CITY OF DOVER

PLANNING TECHNICAL REVIEW COMMITTEE –AGENDA

PLAN SNAPSHOT REPORT SITE-2023-0011 FOR CITY OF DOVER, N.H.

Plan Type: Site Plan - Major
Work Class: New Construction
Status: Review Expired
Valuation: \$0.00
Description: Proposed 3,300 sq ft - Bank with Drive-Up ATM

STONEFIELD engineering & design 120 Washington Street, Suite 201, Salem, MA 01970 Phone 617.233.2076 www.stonfieldeng.com	
CHASEO CHASE BANK WITH DRIVE-THRU ATM 120 WEBB PLACE SALEM, MA 01970 STAFFORD COUNTY, NEW HAMPSHIRE	
SCALE: 1" = 30' PROJECT NO: 009-00111 TITLE: UTILITY PLAN DRAWING: C-6

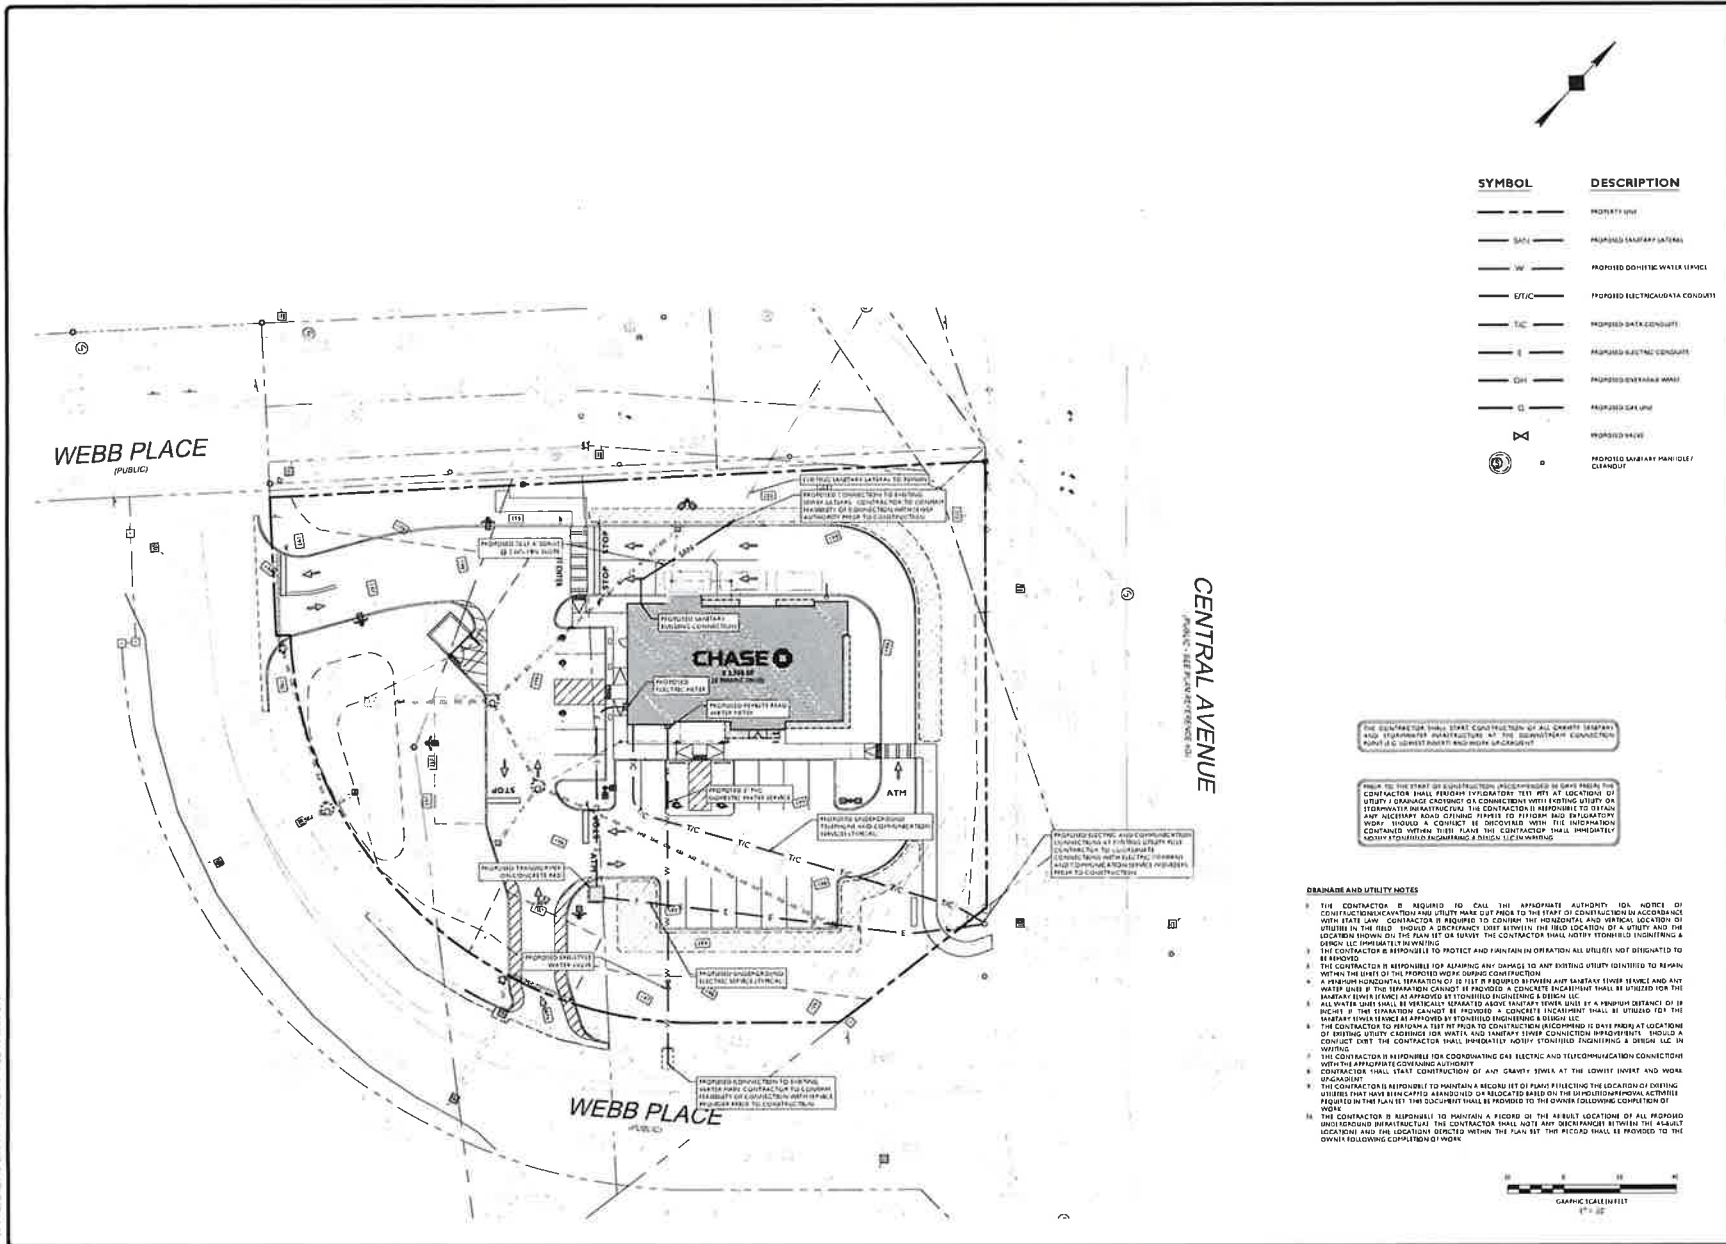
- o Applicant should inspect existing sewer lateral and provide report and video on existing condition. Applicant is reminded that they own from the building to the sewer main.

- o Existing sewer runs across adjacent property. Applicant should engage with abutter to discuss a sewer easement if one does not exist.
- o Sewer in adjacent parking lot has two conflicting sizes noted (6" unk and 12" steel). Applicant should clarify how this data was determined and which is correct.

- o 4-inch sewer should have a minimum 2% slope for sewer not 1.08% as noted on the plan.
- Sheet C-7:
- o Lighting is spilling across the property lines. Please provide light shields.

The Utility Plan (Sheet C-6) has been revised to relocate the water service connection originally proposed to Central Avenue to Webb Place in order to minimize bends in the service. There is no other disturbance in the Central Avenue sidewalk.

The Utility Plan (Sheet C-6) has been revised to indicate a 2" PVC domestic water service line.

The Utility Plan (Sheet C-6) has been revised to locate water service in an orientation which eliminates the need for bends and insulation.

**GRADING &
DRAINAGE PLAN**

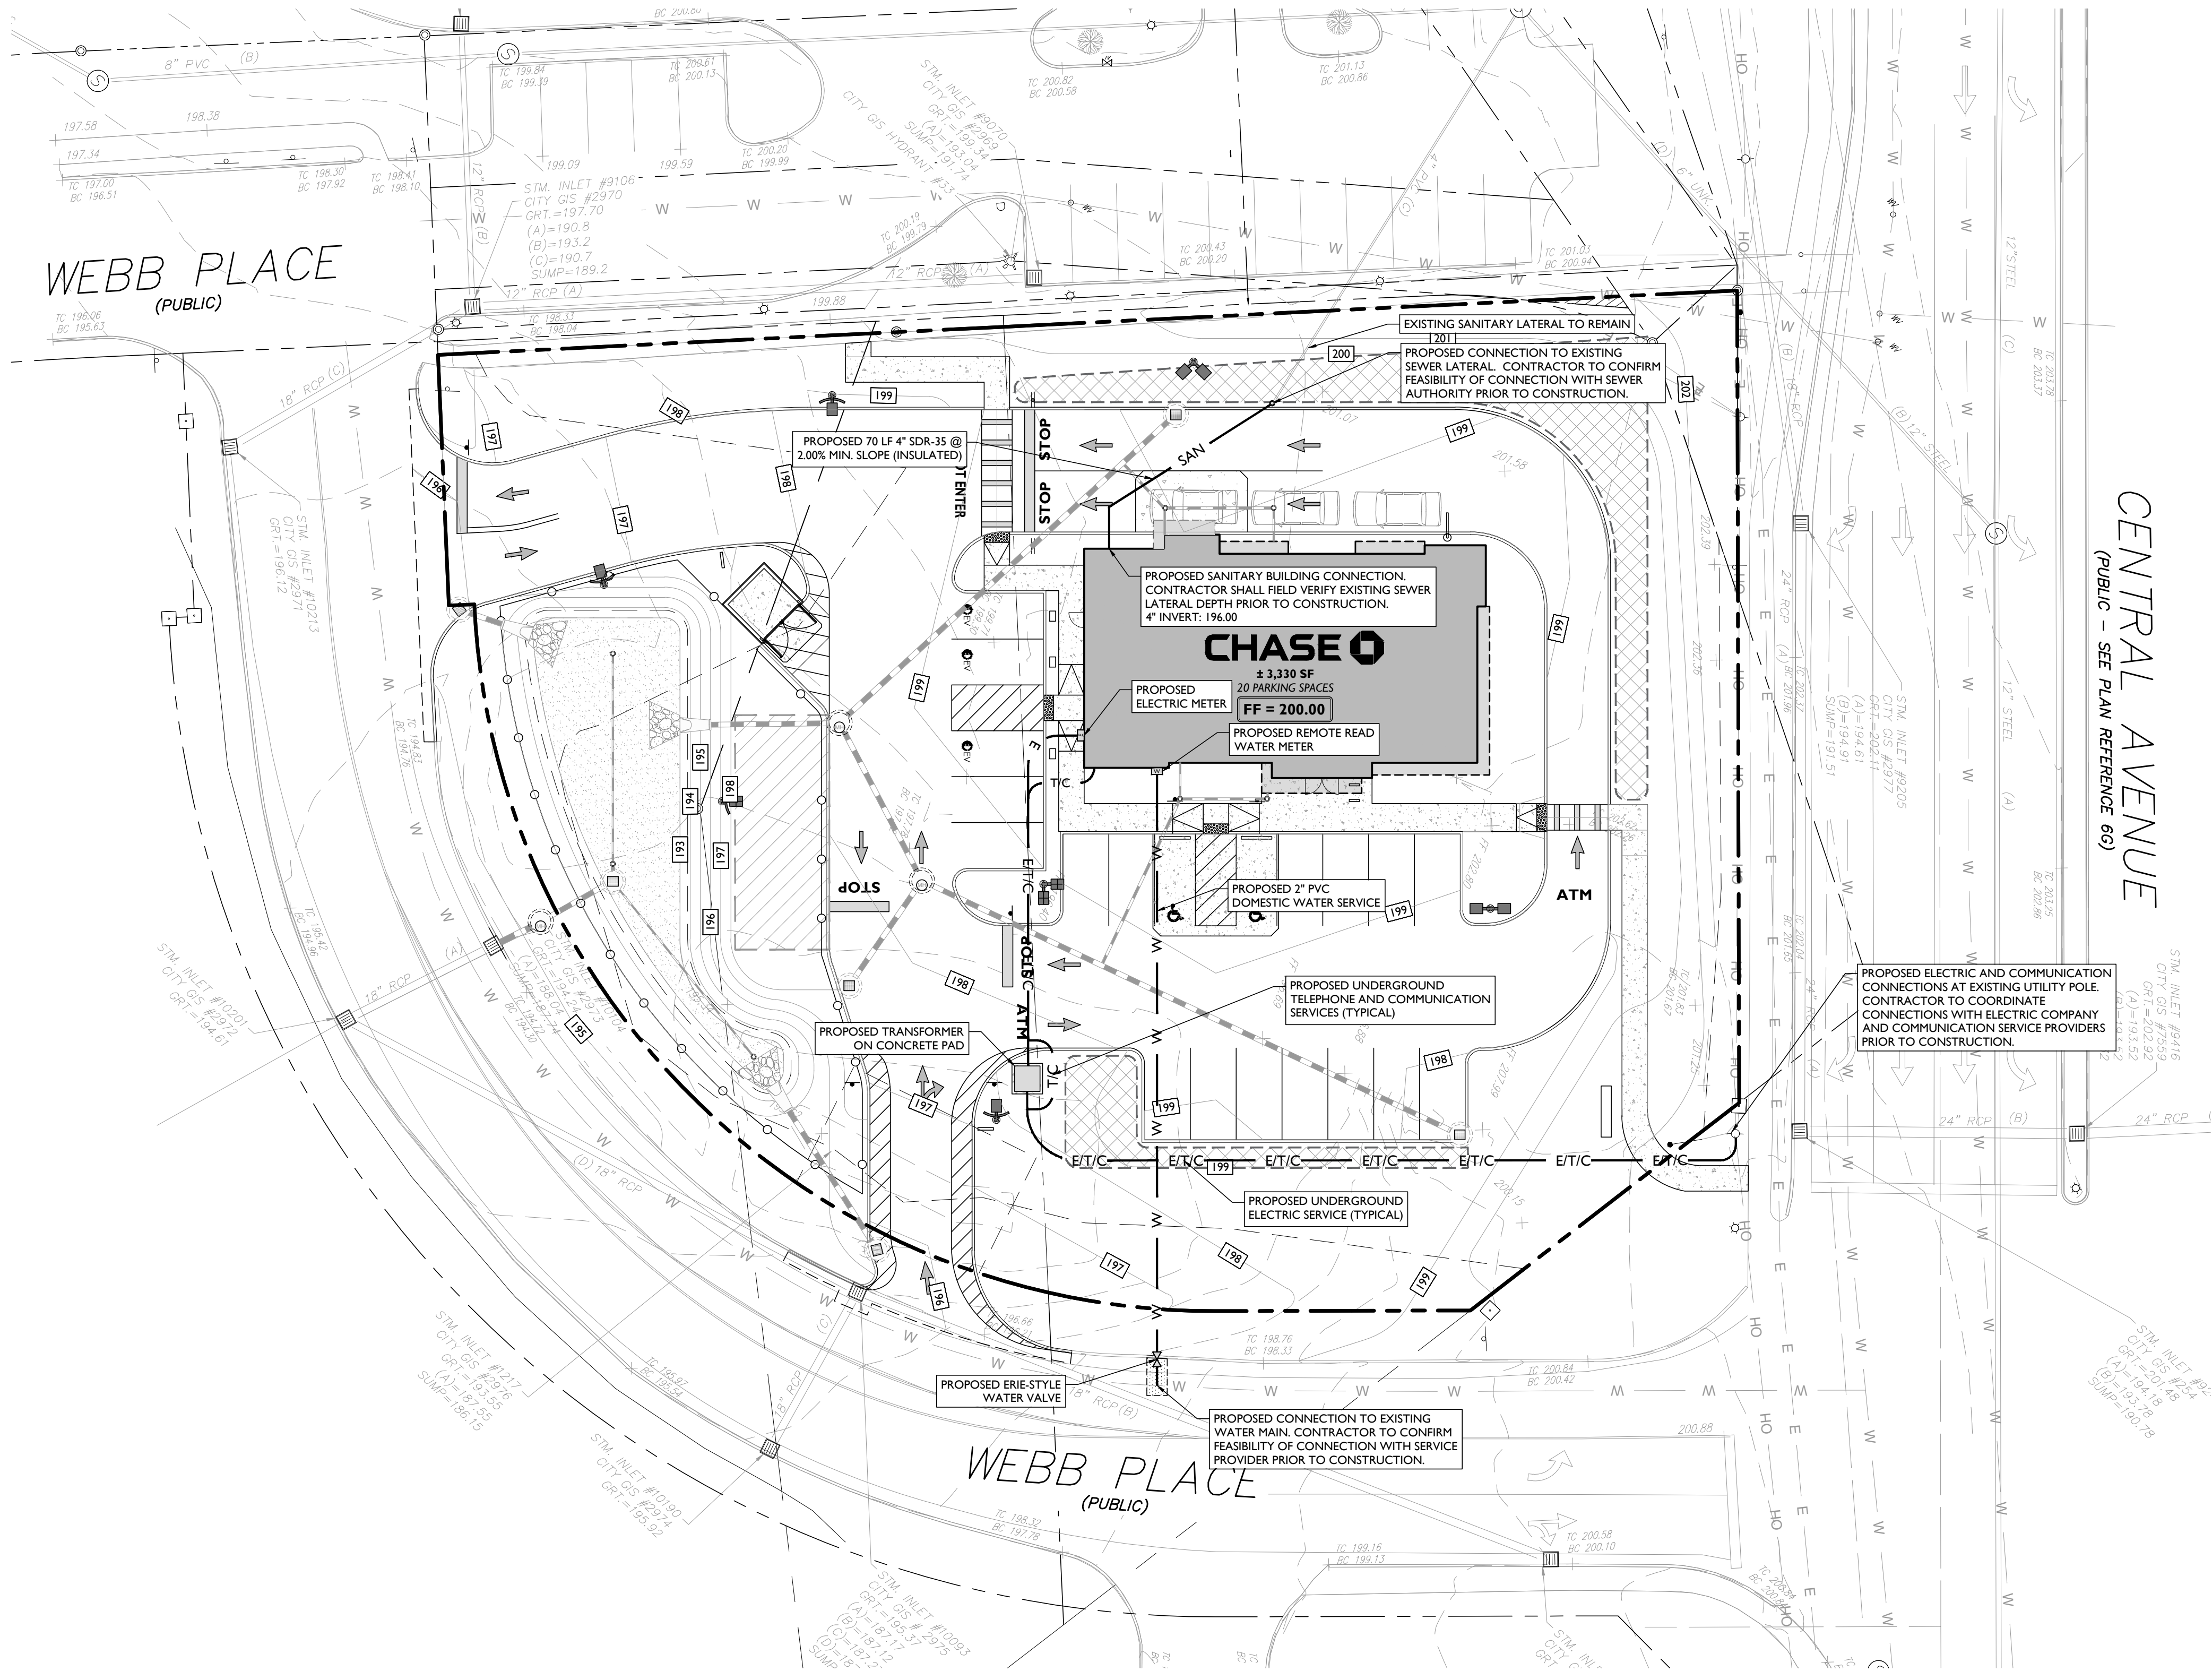
o Provide pretreatment for stormwater basin. Recommend offline catch basins with deep sumps and oil separator hoods.

o Provide a minimum 3 feet of cover on all storm drainage pipe.

o Drop off from parking area is over 5 feet. Clarify if guardrail is required.

o Provide calculations and details for rip rap apron in stormwater basin.

The Grading & Drainage Plan (Sheet C-5) has been revised to modify the pipe network entering the proposed storm manholes D-201 and D-203 at angles that do not conflict. As part of the shop drawing construction process a larger structure may be selected if deemed necessary.

Based on feedback from the meeting the building finished floor elevation was reduced and the Grading & Drainage Plan (Sheet C-5) has been revised to reduce the driveway slopes to 3.5% to 4.5% within 75 FT of intersections. The existing driveway slope within 75-feet of the intersection is around 6% so the project will be an improvement.

The Grading & Drainage Plan (Sheet C-5) has been revised to show a proposed curb inlet at the driveways that punch directly into the bioretention area.

TRASH ENCLOSURE DETAIL

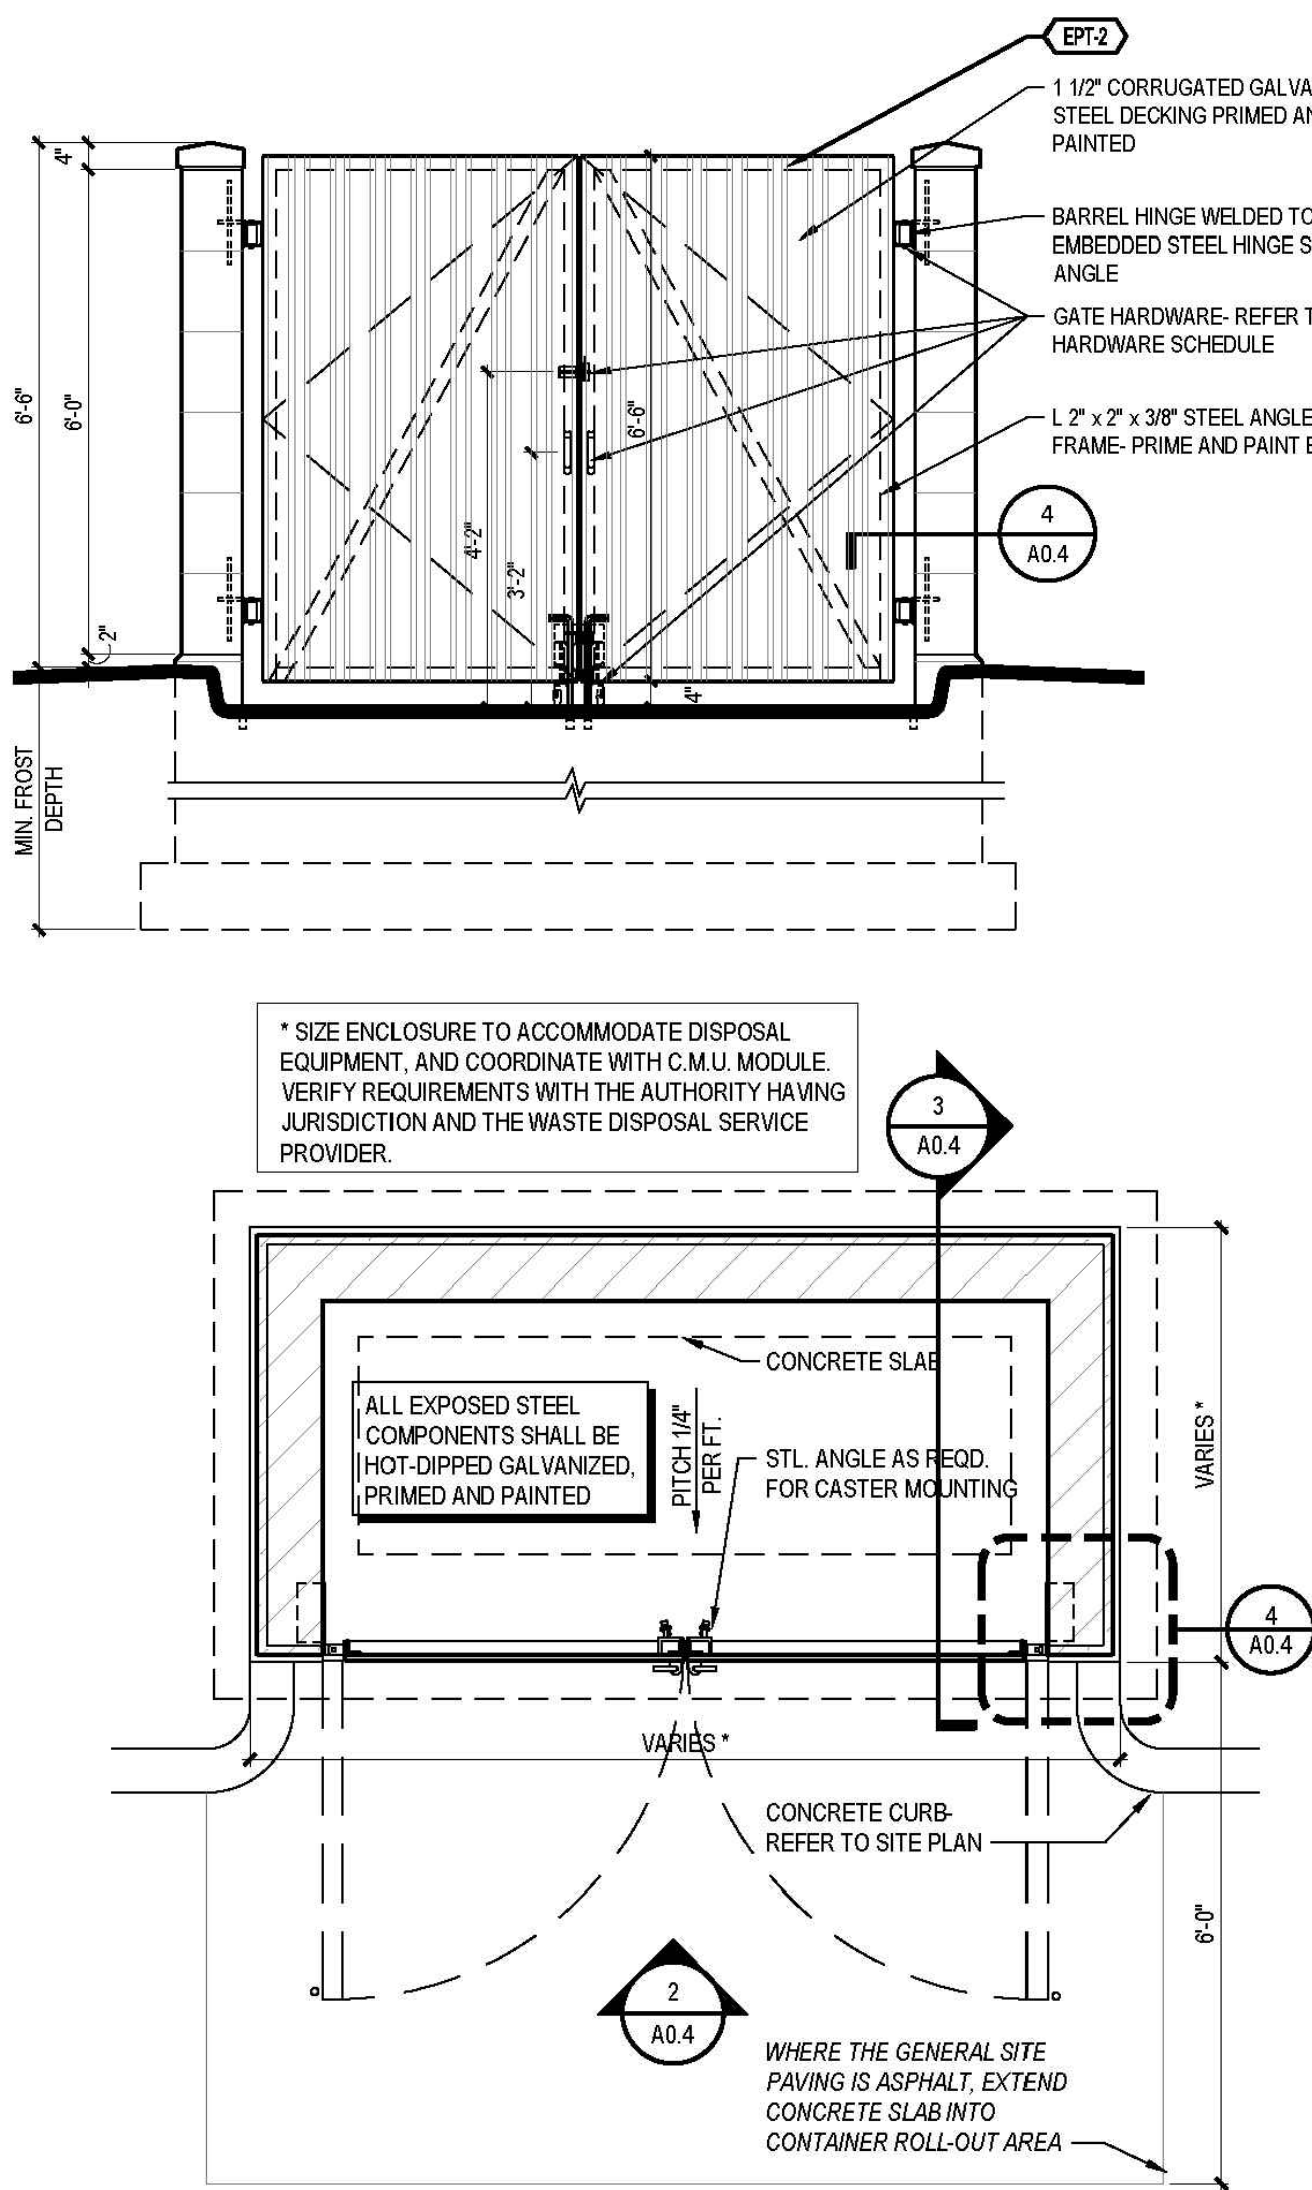
- o Curbing in City right of way shall be granite.
- Sheet C-13:
- o Provide minimum frost depth on detail no. 8.
- o Provide details on foundation for clearance bar. Notes appear to be scanned and are not legible.

The Trash Enclosure Detail (Sheet C-14) has been revised to indicate a minimum frost depth of 4 FT below grade within the notes. Detail no 6 was previously the concrete wheel stop detail but we believe this was meant for the trash enclosure detail.
